Product Change Notification

Change Notification #: **106293 - 00**

Change Title: **Intel NetStructure® MPCBL0030S03Q Single Board Computer, PCN 106293-00, Product Design, Rework changes as noted**

Date of Publication: **May 05, 2006**

Figure 1. Capacitor and Resistor changes.

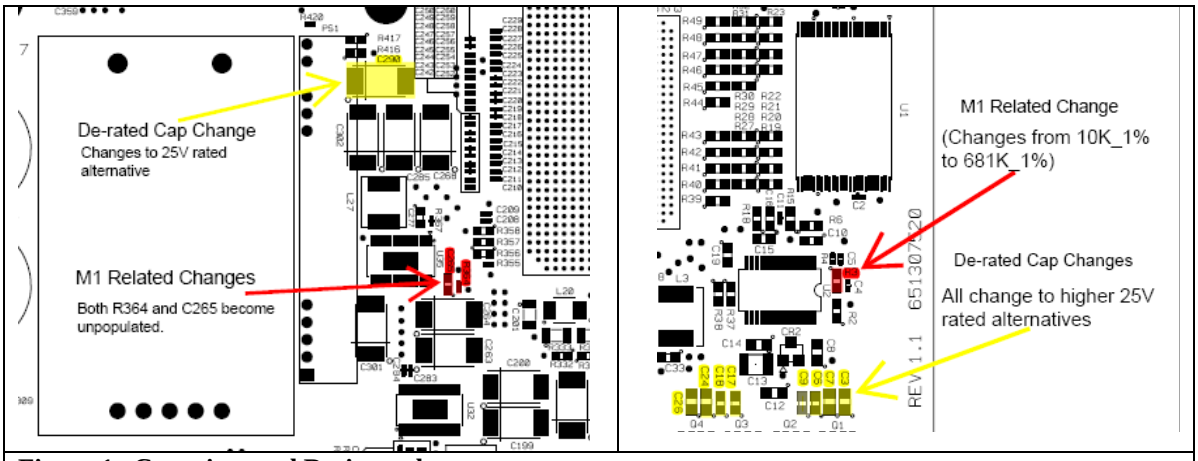
1. Change Capacitors to obtain a larger voltage derating

Perform changes to all BOM configurations denoted for derated capacitor corrections as noted in Table 1 and Figure 1.

Location	Remove	Replace with	Reason
C3, C7, C24, C26	Murata: GRM21BR60J106K at 6.3Vdc	Murata: GRM21BR61E475KA12L at 25Vdc	Change from 6.3V rated to 25Vdc rated Ceramic-X5R dielectric capacitor
C6, C9, C17, C18	Panasonic: ECJ1VB0J105K at 6.3V dc	Murata: GRM188R61E105KA12D at 25Vdc	Change from 6.3V rated to 25Vdc rated Ceramic-X7R dielectric capacitor
C290	AVX Kyoura: TAJD476K016R at 16Vdc	KEMET T491D476K025AS at 25Vdc	Change from 16Vdc to 25Vdc rated Tantalum - conductive polymer capacitor

2. Updates to resistors and capaitors for power sequencing issues.

The following changes will improve power on sequence and reduce incidence of “M1 Related” or “Power Unit Failure” reports, as noted in Table 2, and shown in Figure 1.

C265	.047UF capacitor		Unpopulate capacitor
R364	0 Ohm		Unpopulate Resistor
R3	10K	681K	Change resistor value
